**World Forum for Harmonization of Vehicle Regulations****Working Party on General Safety Provisions****127th session**

**Amendments to Gas-Fuelled Vehicle Regulation:****UN Regulation No. 110 (Compressed Natural Gas and Liquefied Natural Gas vehicles)****Proposal for Supplement 10 to the original version of UN  
Regulation No. 110 (Compressed Natural Gas and Liquefied  
Natural Gas vehicles)****Submitted by the expert from the European Association of Automotive  
Suppliers \***

The text reproduced below has been prepared by the expert from the European Association of Automotive Suppliers (CLEPA). Various options that fulfil the marking requirements of E-Marking are proposed, while avoiding duplication when more than one UN Regulation applies as is the current case of UN Regulation No. 107. A reduced-size E-Marking is also proposed as in the current cases of UN Regulations No. 67 and No. 158. The proposal is particularly relevant for small-size components. The modifications to the current text of the UN Regulation are marked in bold for new or strikethrough for deleted characters.

##### Example 2

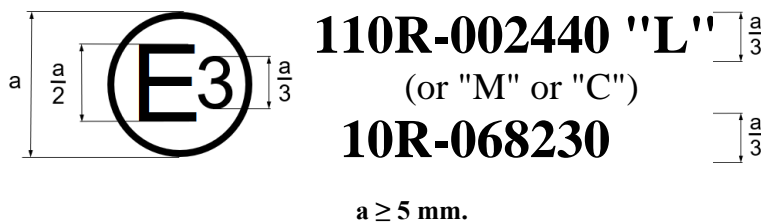
(See paragraph 5.4.3. of this Regulation)

This approval mark when affixed to the CNG and or LNG component shows that this component has been approved in Italy (E 3), pursuant to Regulation No. 110 under approval number 002440 and pursuant to UN Regulation No. 10<sup>1</sup> under approval number 068230. The first two digits of the first approval number indicate that the approval was granted in accordance with the requirements of UN Regulation No. 110 in its original form.

The first two digits of the second approval number indicate that the approval was granted in accordance with the requirements of UN Regulation No. 10 as amended by the 06 series of amendments.
